STATE OF MAINE
DEPARTMENT OF TRANSPORTATION
16 STATE HOUSE STATION
AUGUSTA, MAINE 04333-0016

January 7, 2020
Subject: Drainage & Safety
Improvements
State WIN: 019402.00
Location: **Augusta**
Amendment No. 3

Please make the following changes to the Bid Documents:

Date: 1/6/2020

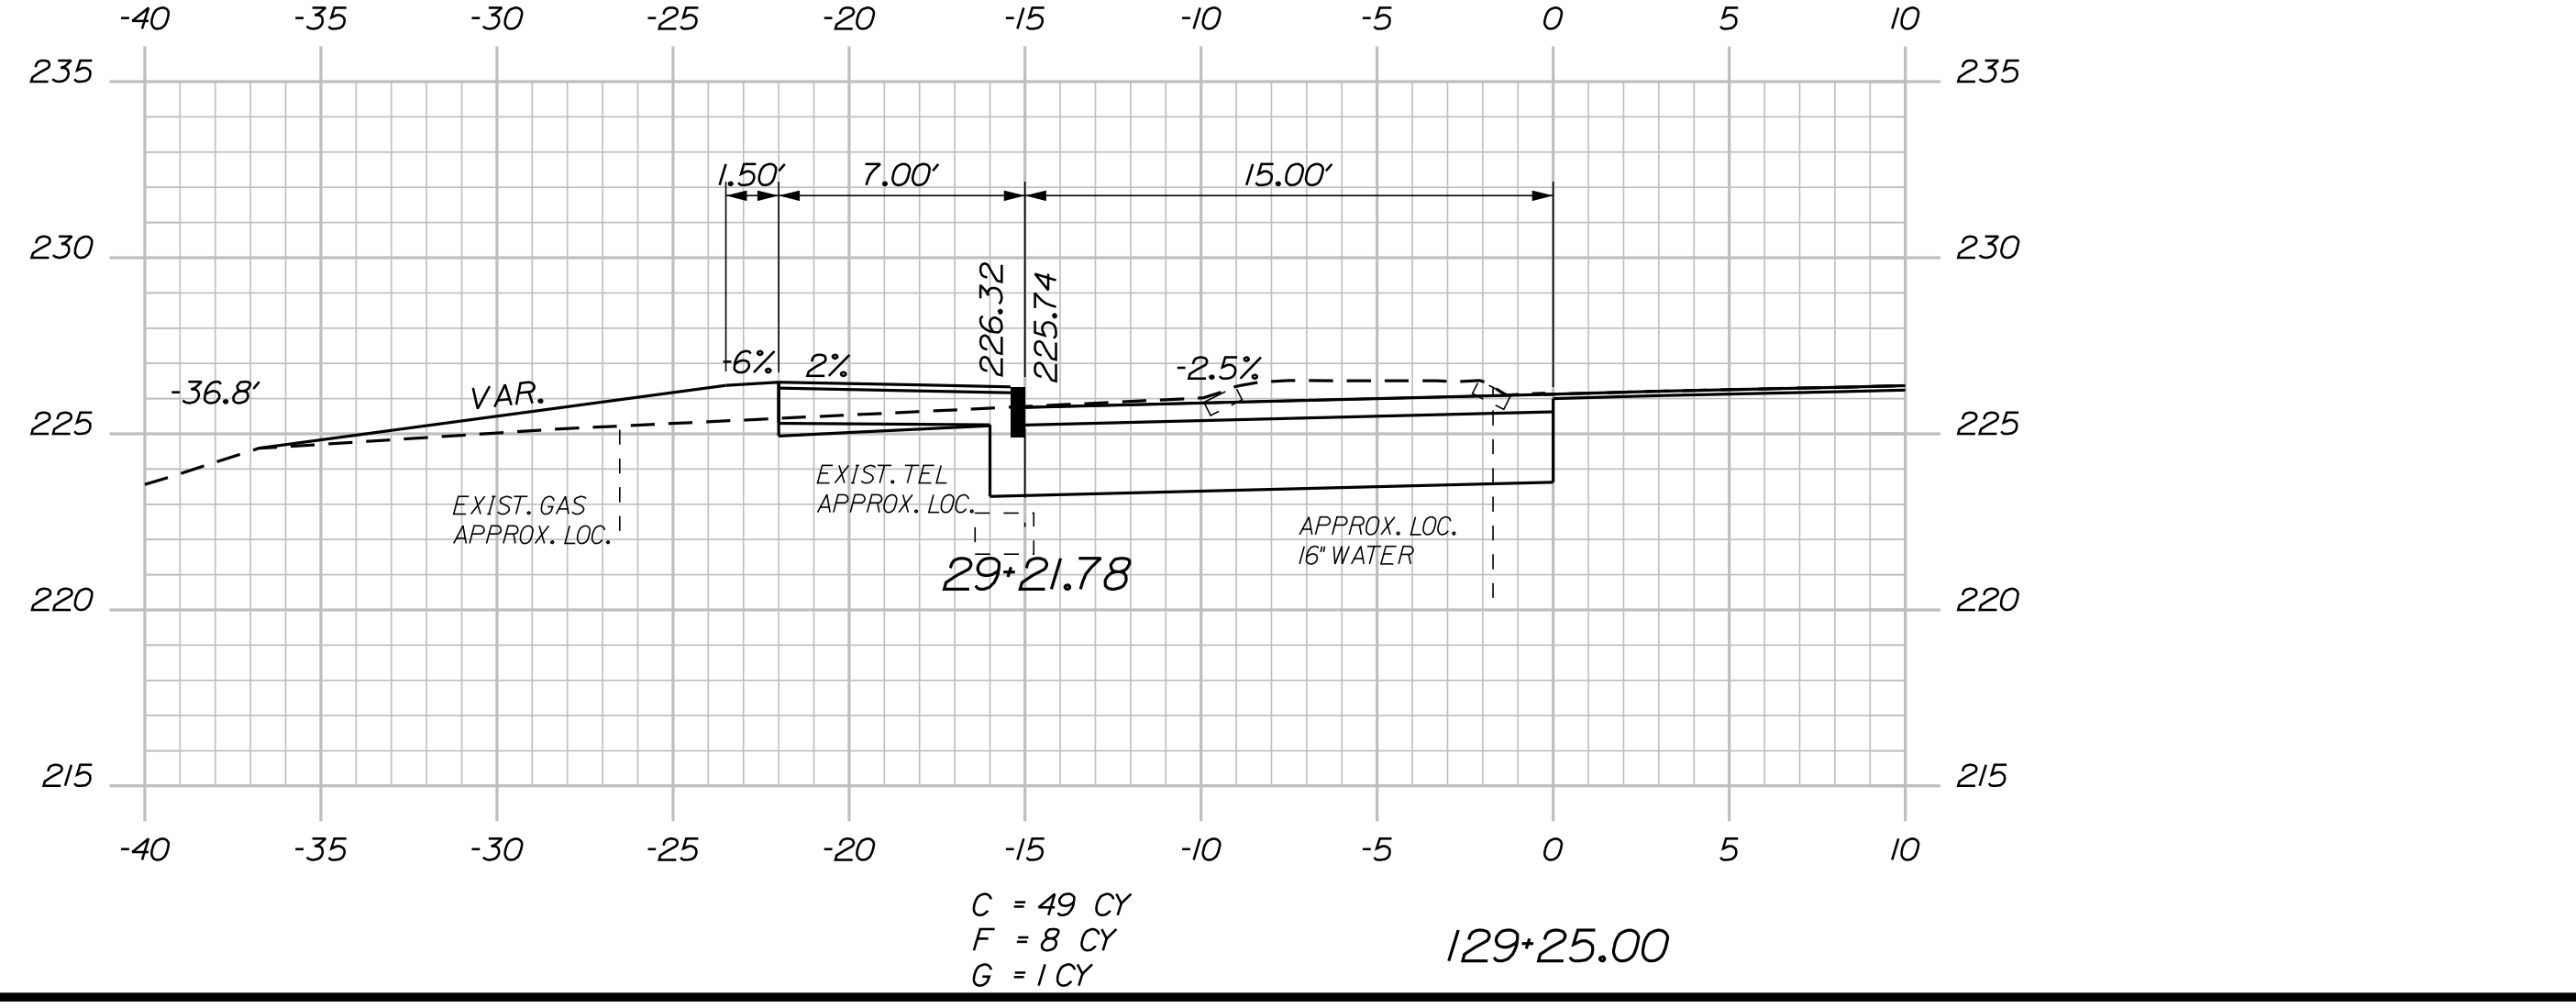
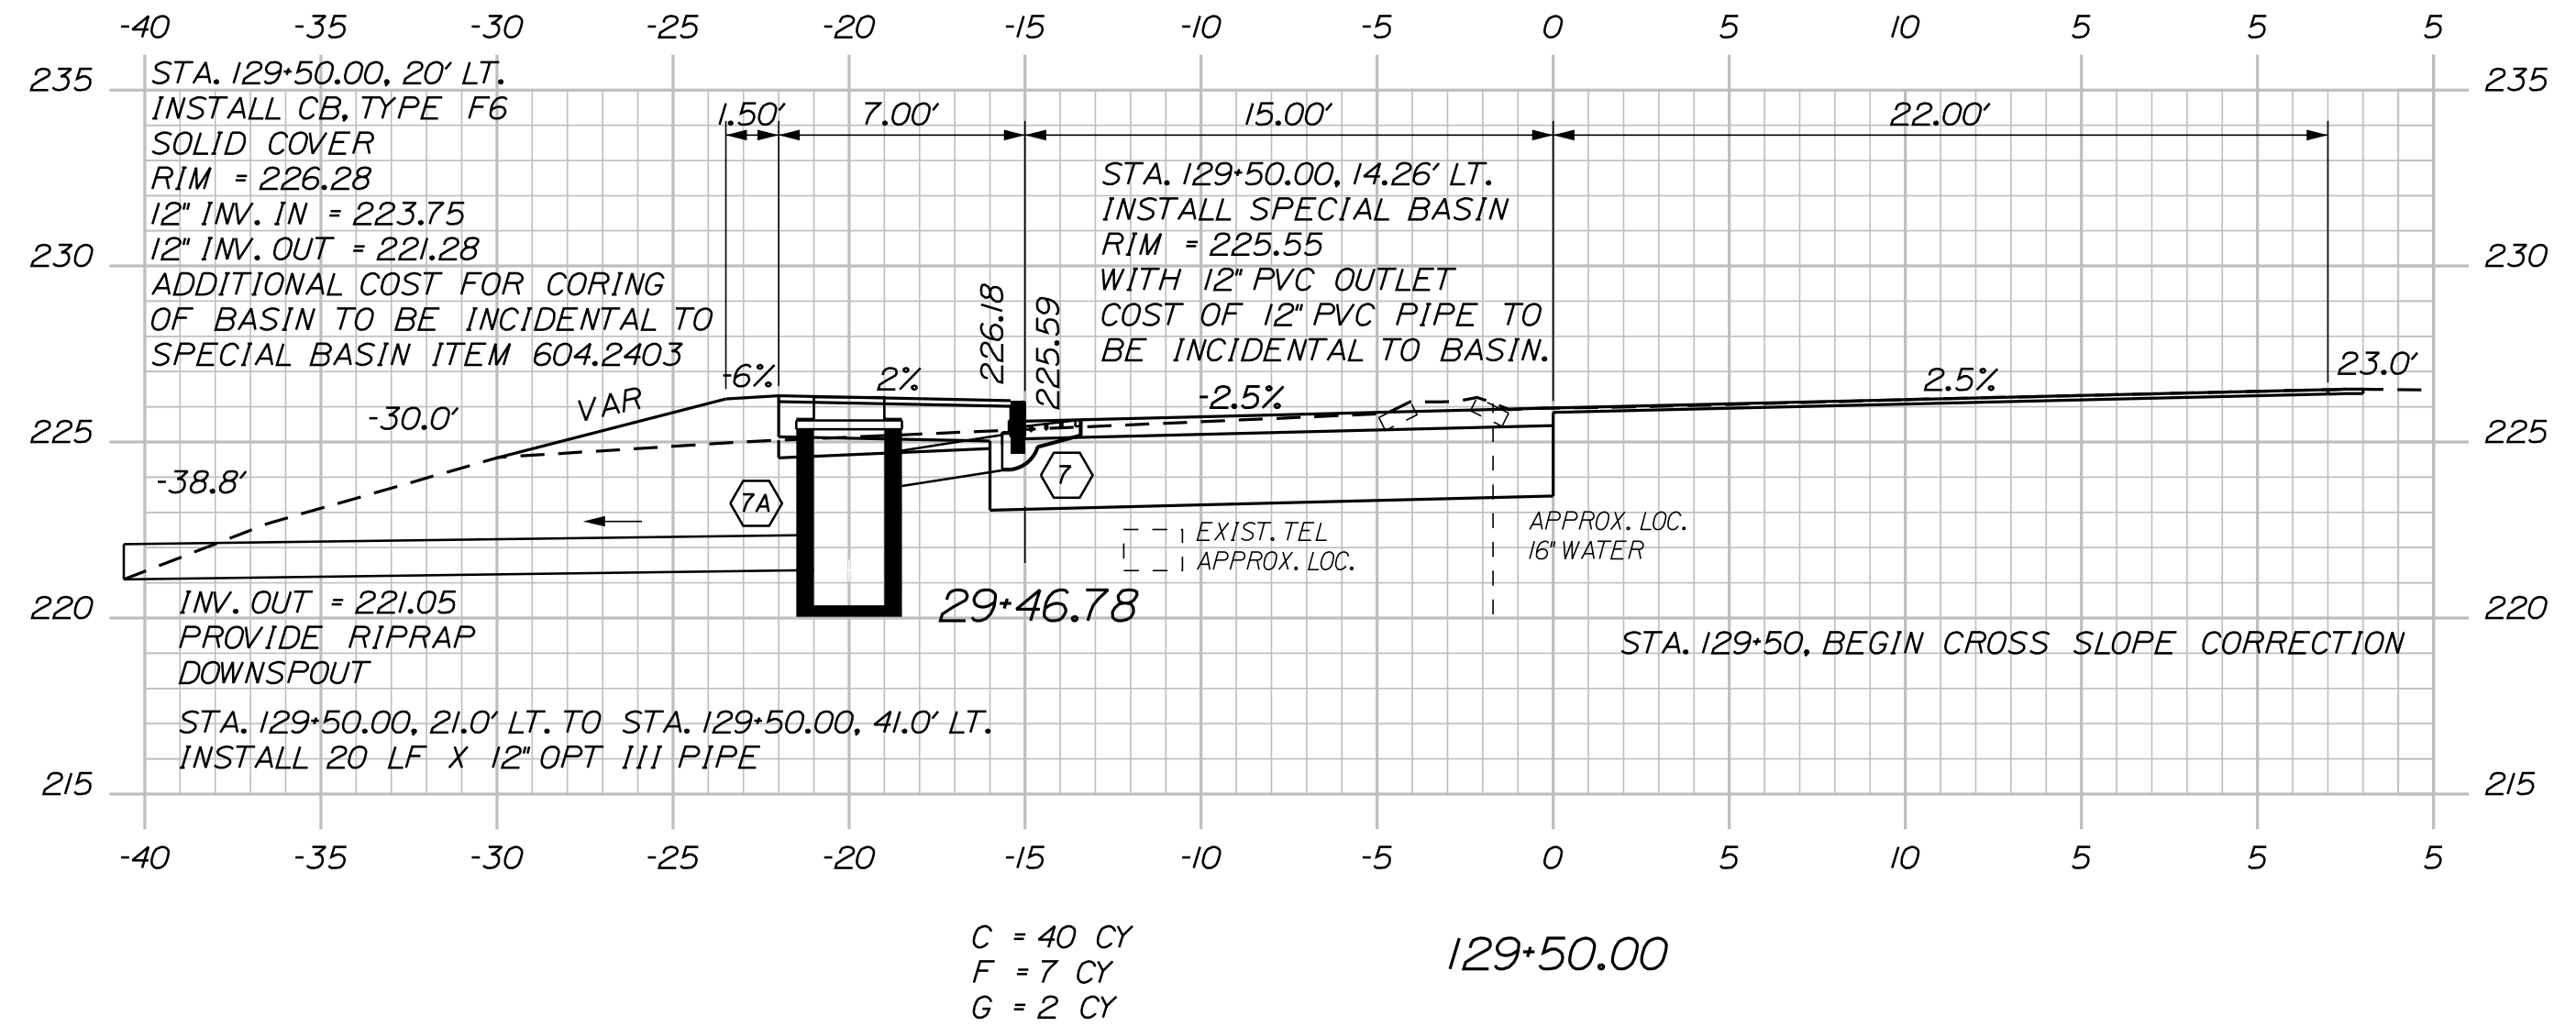
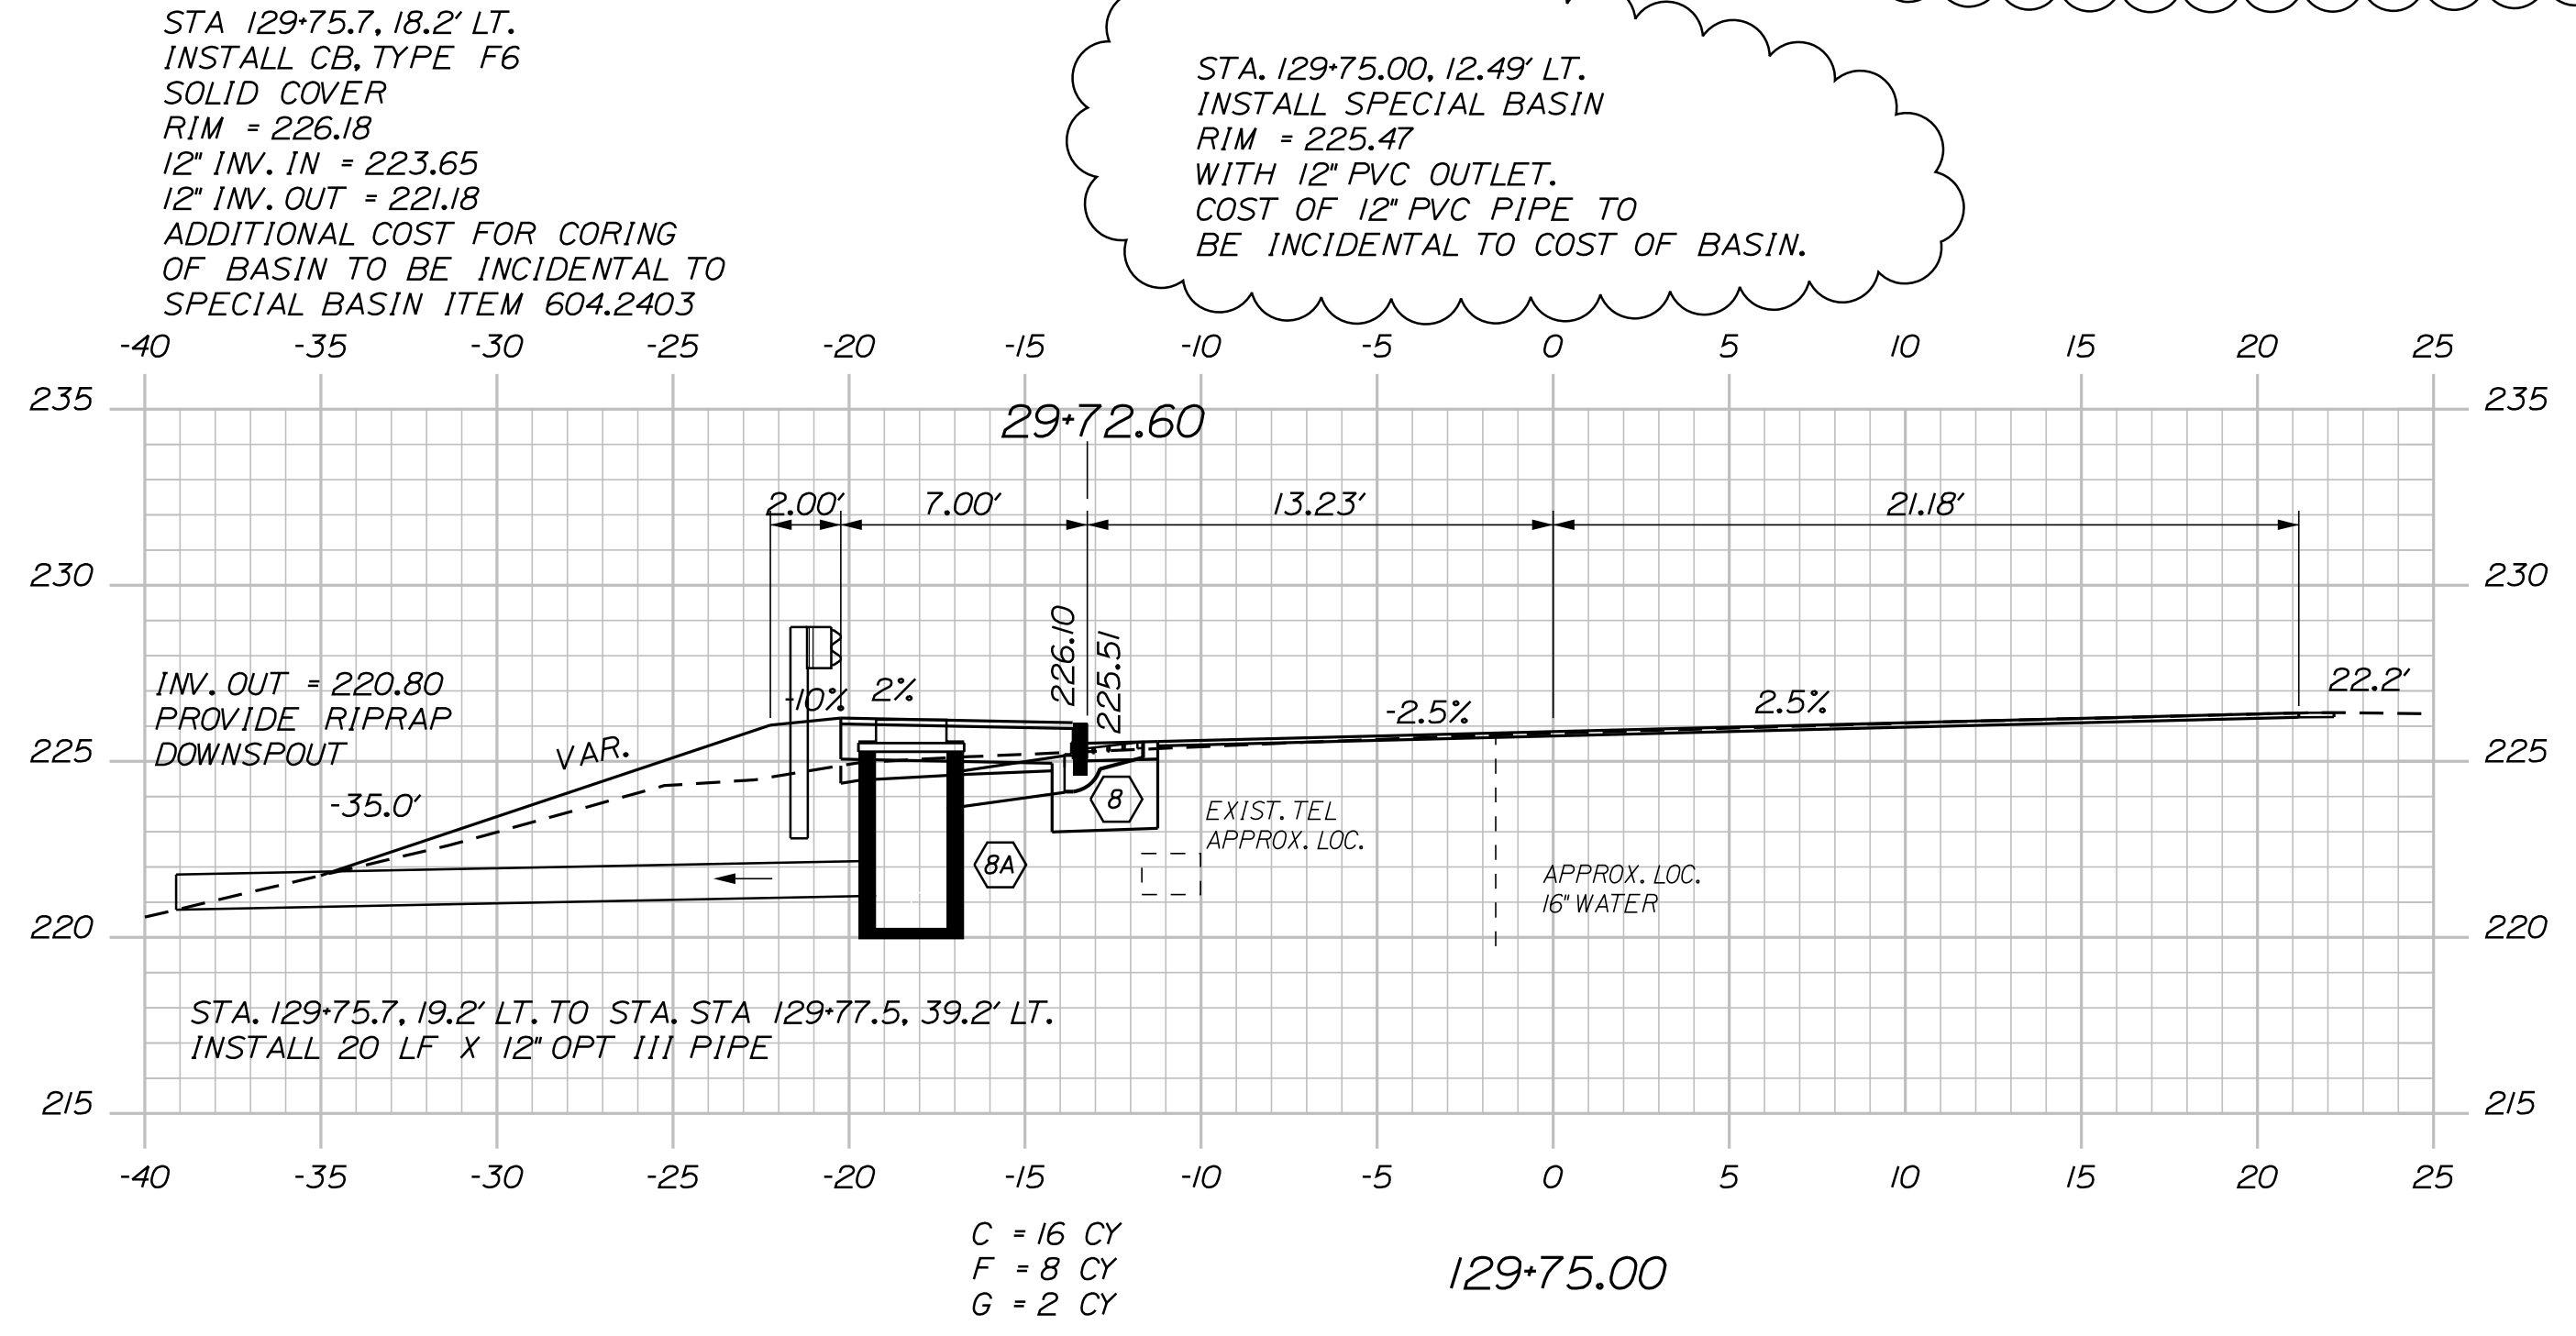
TEST PIT AT BASINS 7&8 TO VERIFY CONFLICT WITH BURIED TELEPHONE CONDUIT PRIOR TO ORDERING SPECIAL BASIN ITEM 604.2403.
